## Changes to proposed District Map Amendment G-956

A revised version of DMA G-956, dated April 18, 2014, has been posted on the Planning Department website for review. It contains all of the proposed and approved changes that have occurred since March 7, 2014. The following document illustrates all of the changes to DMA G-956.

Changes made to DMA G-956 are organized into two sections, each section describing a different type of revision.

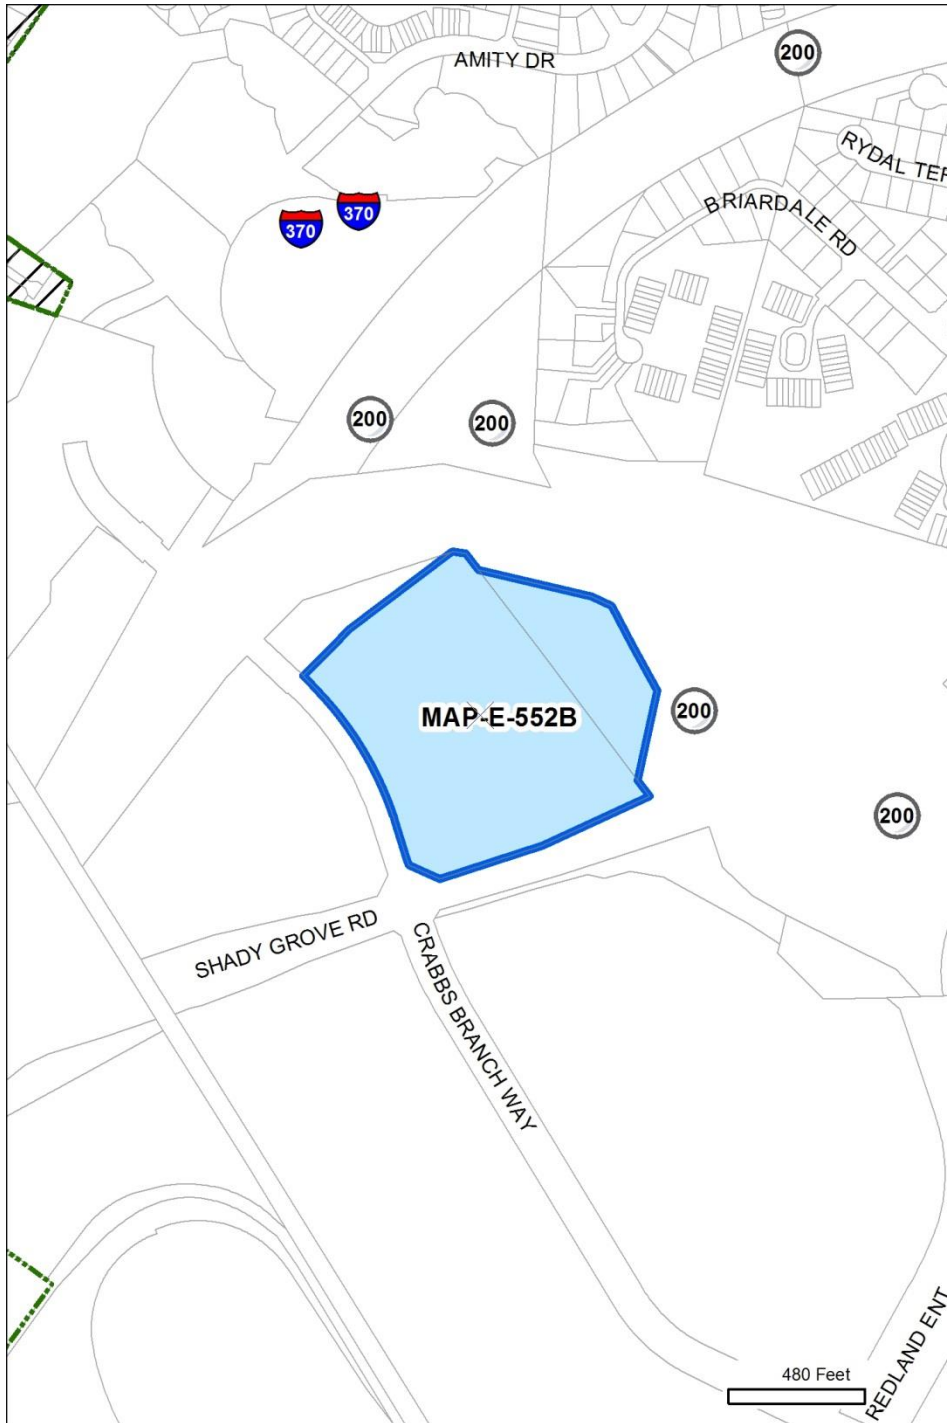
Unique ID: MAP-E-552A		staff error
Master Plan ID: SDYGR-04		
Master Plan:		Shady Grove
Location:		
Existing Zone:		RMX-2C/TDR
Proposed Conv: (3/7)		CRT-1.0 C-0.5 R-0.75 H-65 T
Prop. Revised Conv:		CRT-1.0 C-0.5 R-0.5 H-65 T
Category:		Error
Modifications	Zone Group:	No change
	Overall FAR:	No change
	Comm'l FAR:	No change
	Resid'l FAR:	Reduced to 0.5
	Height:	No change
<b>Reason for change:</b>		
<p><i>The master plan calls for a base (non-TDR) density of 300 dwelling units on this site. That would be approximately 0.5 FAR, given the multi-family units contemplated.</i></p> <p><i>As a result, the residential FAR should be lowered to 0.5.</i></p> <p><i>The TDR Overlay should also be lowered by a commensurate amount (see <b>MAP-E-552B</b>).</i></p>

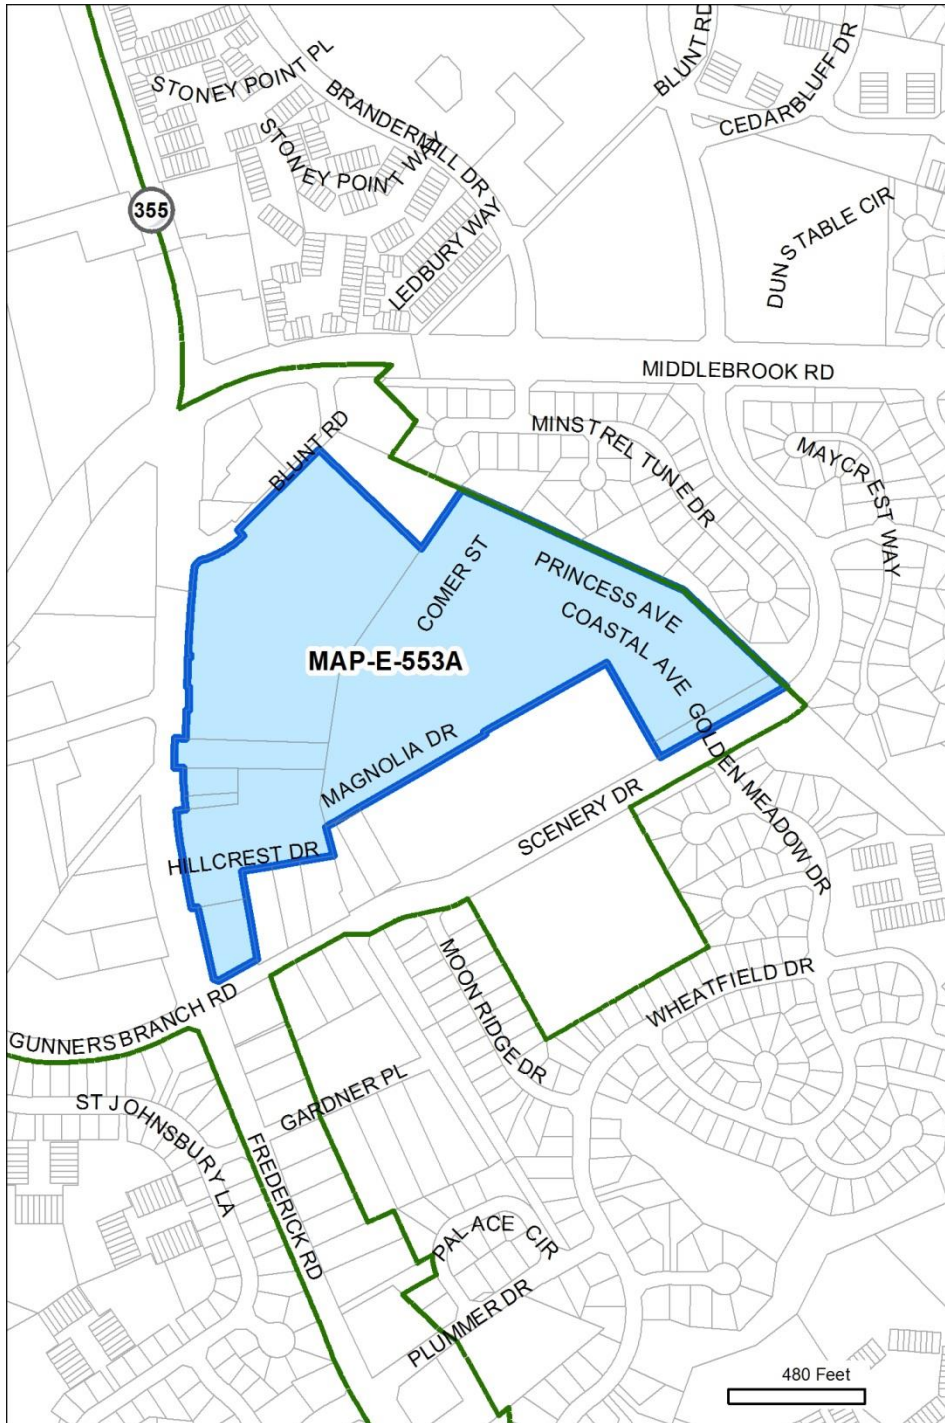
Unique ID: MAP-E-552B		staff error
Master Plan ID: SDYGR-04		
Master Plan:		Shady Grove
Location:		
Existing Zone:		RMX-2C/TDR
Proposed Conv: (3/7)		<del>TDR-1.06</del>
Prop. Revised Conv:		TDR-0.81
Category:		Error
Modifications	Zone Group:	No change
	Overall FAR:	No change
	Comm'l FAR:	No change
	Resid'l FAR:	No change
	Height:	No change
<b>Reason for change:</b>		
<p><i>The master plan calls for a base (non-TDR) density of 300 dwelling units on this site. That would be approximately 0.5 FAR, given the multi-family units contemplated.</i></p> <p><i>As a result, the residential FAR should be lowered to 0.5 (see <b>MAP-E-552A</b>).</i></p> <p><i>The TDR Overlay should also be lowered by a commensurate amount, from 1.06 to 0.81.</i></p>

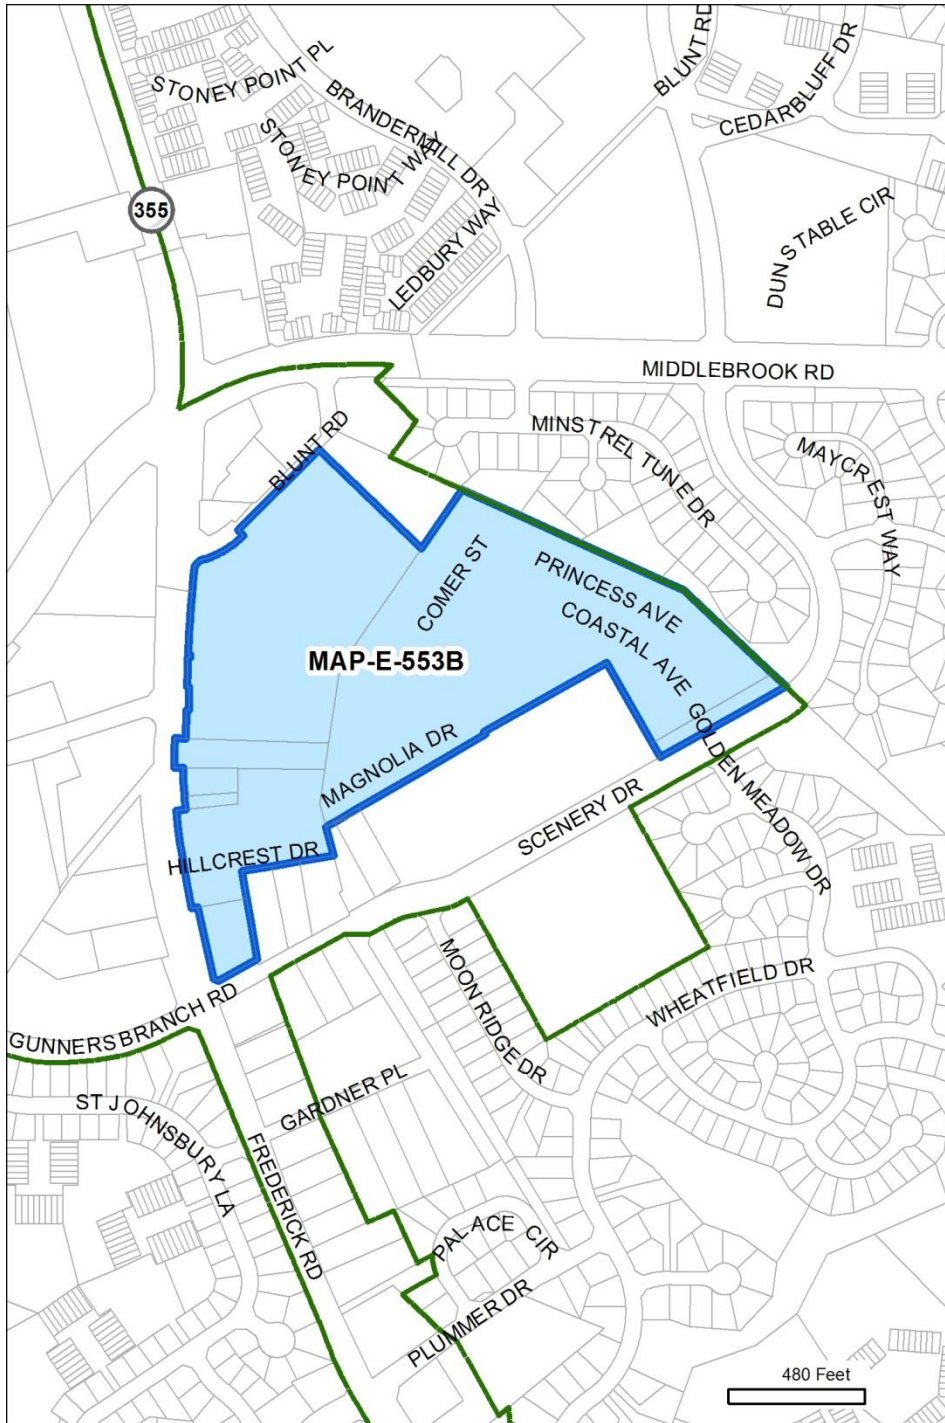
Unique ID: MAP-E-553A		staff error
Master Plan ID: GRMTC-28		
Master Plan:	Germantown Town Center	
Location:		
Existing Zone:	RMX-2C/TDR	
Proposed Conv: (3/7)	<del>CRT-1.25 C-0.5 R-0.75 H-60 T</del>	
Prop. Revised Conv:	CRT-1.0 C-0.5 R-0.5 H-60 T	
Category:	Error	
Modifications	Zone Group:	No change
	Overall FAR:	Reduced to 1.0
	Comm'l FAR:	No change
	Resid'l FAR:	Reduced to 0.5
	Height:	No change
<b>Reason for change:</b>		
<p><i>The master plan calls for up to 22 dwelling units per acre, with a base of 14.5 at R-30 (multi-family) standards. At that base density, development would come to approximately 0.5 FAR.</i></p> <p><i>For that reason, the base R should be 0.5, and the overall FAR should be lowered to 1.0.</i></p> <p><i>The TDR Overlay should also get a commensurate reduction (see <b>MAP-E-553B</b>).</i></p>

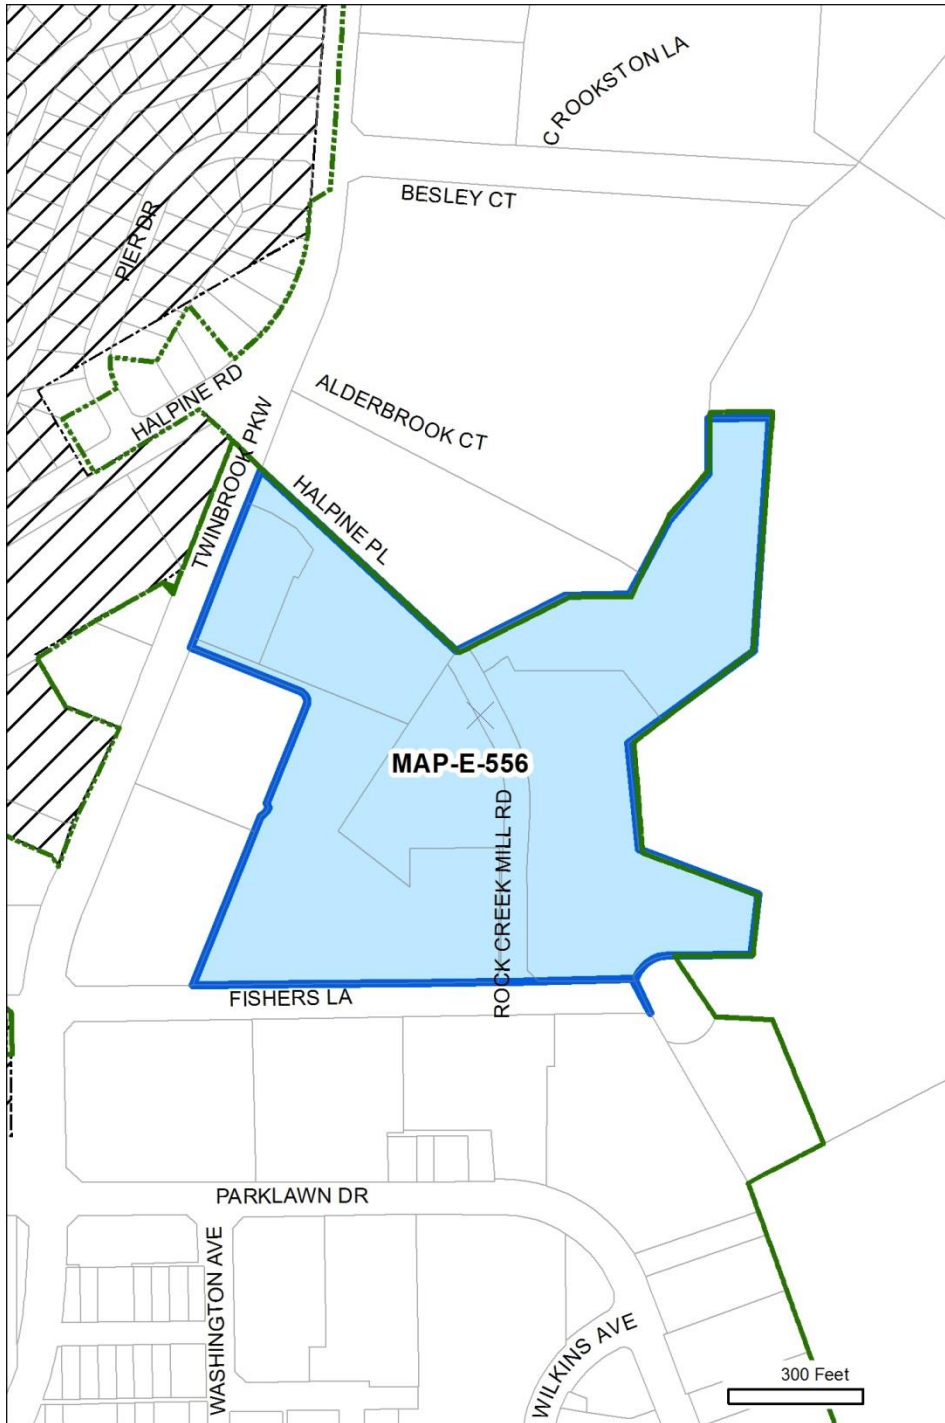
Unique ID: MAP-E-554		staff error
Master Plan ID: TWBRK-01		
Master Plan:		Twinbrook
Location:		
Existing Zone:		TMX-2
Proposed Conv: (3/7)		CR-1.5 C-1.0 R-1.5 H-150 T
Prop. Revised Conv:		CR-1.5 C-1.0 R-1.25 H-145 T
Category:		Error
Modifications	Zone Group:	No change
	Overall FAR:	No change
	Comm'l FAR:	No change
	Resid'l FAR:	Reduced to 1.25
	Height:	Reduced to 145
<b>Reason for change:</b>		
<p><i>The sector plan calls for any project here to have a minimum residential component of 25% and for the maximum FAR to be 1.5.</i></p> <p><i>The initial DMA granted the full 1.5 FAR to the residential component, however, in consistency with other conversions in the TMX-2 zone, the residential component should have been limited to require mixed-use in order to receive the full density.</i></p> <p><i>Additionally, the sector plan calls for limiting height throughout the sector plan area to 143', so the height should also be reduced.</i></p>

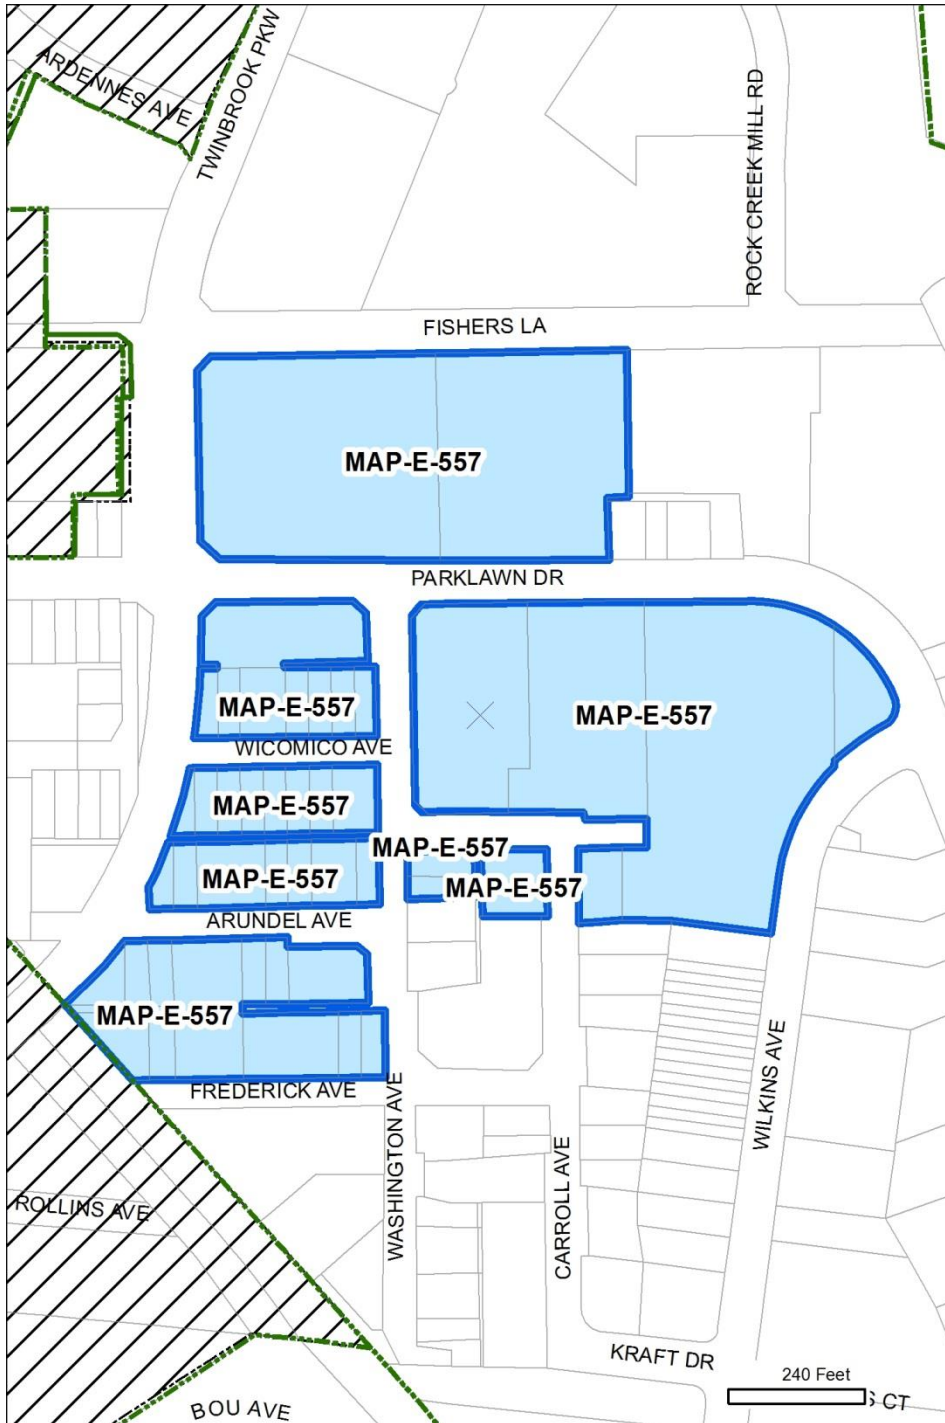
<b>Unique ID:</b> MAP-E-556		staff error
<b>Master Plan ID:</b> TWBRK-02		
<b>Master Plan:</b>	Twinbrook	
<b>Location:</b>		
<b>Existing Zone:</b>	TMX-2	
<b>Proposed Conv:</b> (3/7)	<del>CR-1.5 C-1.5 R-1.5 H-150 T</del>	
<b>Prop. Revised Conv:</b>	CR-1.5 C-1.5 R-1.5 H-145 T	
<b>Category:</b>	Error	
<b>Modifications</b>	<b>Zone Group:</b>	No change
	<b>Overall FAR:</b>	No change
	<b>Comm'l FAR:</b>	No change
	<b>Resid'l FAR:</b>	No change
	<b>Height:</b>	Reduced to 145
<b>Reason for change:</b>		
<i>The sector plan calls for limiting height throughout the sector plan area to 143', so the height should be reduced.</i>

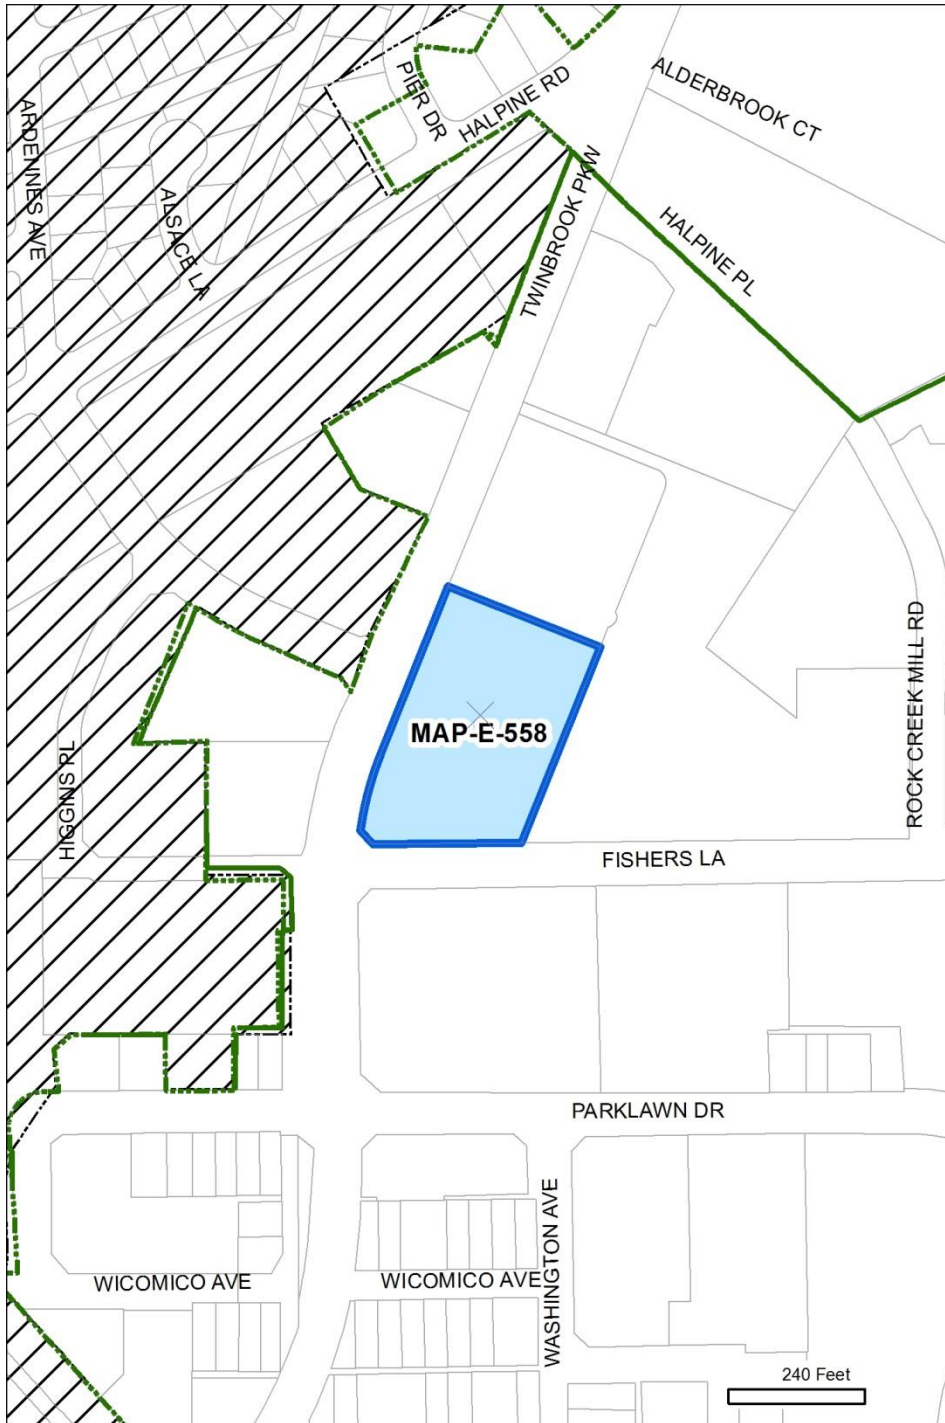
Unique ID: MAP-E-557		staff error
Master Plan ID: TWBRK-03		
Master Plan:	Twinbrook	
Location:		
Existing Zone:	TMX-2	
Proposed Conv: (3/7)	<del>CR-2.0 C-1.5 R-2.0 H-150 T</del>	
Prop. Revised Conv:	CR-2.0 C-1.5 R-2.0 H-145 T	
Category:	Error	
Modifications	Zone Group:	No change
	Overall FAR:	No change
	Comm'l FAR:	No change
	Resid'l FAR:	No change
	Height:	Reduced to 145
Reason for change:		
<i>The sector plan calls for limiting height throughout the sector plan area to 143', so the height should be reduced.</i>

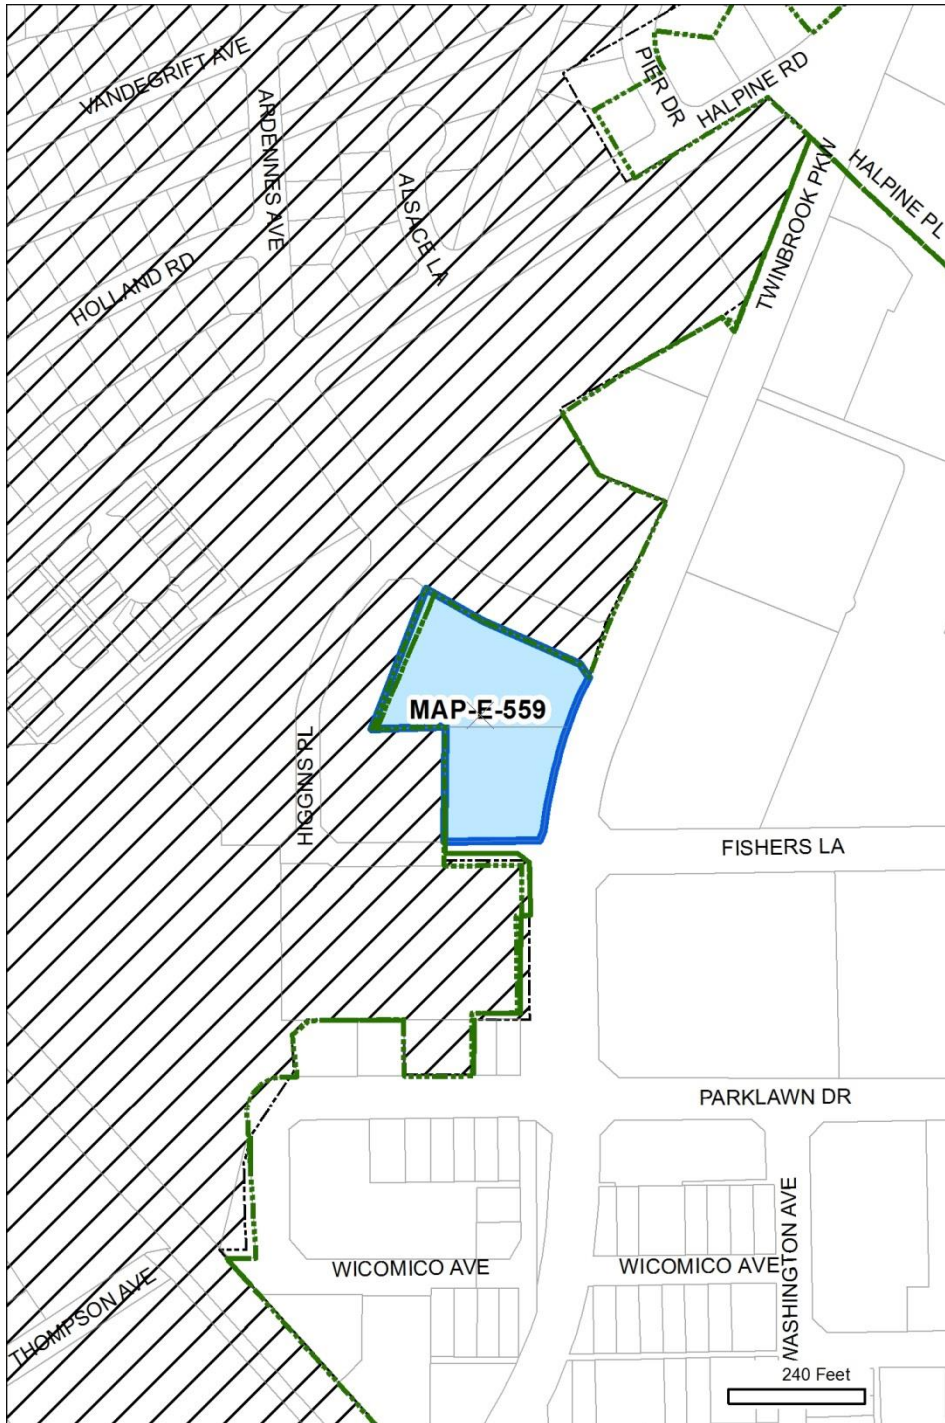
Unique ID: MAP-E-558		staff error
Master Plan ID: TWBRK-04		
Master Plan:	Twinbrook	
Location:		
Existing Zone:	TMX-2	
Proposed Conv: (3/7)	<del>CR-2.0 C-2.0 R-1.5 H-150 T</del>	
Prop. Revised Conv:	CR-2.0 C-2.0 R-1.5 H-145 T	
Category:	Error	
Modifications	Zone Group:	No change
	Overall FAR:	No change
	Comm'l FAR:	No change
	Resid'l FAR:	No change
	Height:	Reduced to 145
Reason for change:		
<i>The sector plan calls for limiting height throughout the sector plan area to 143', so the height should be reduced.</i>
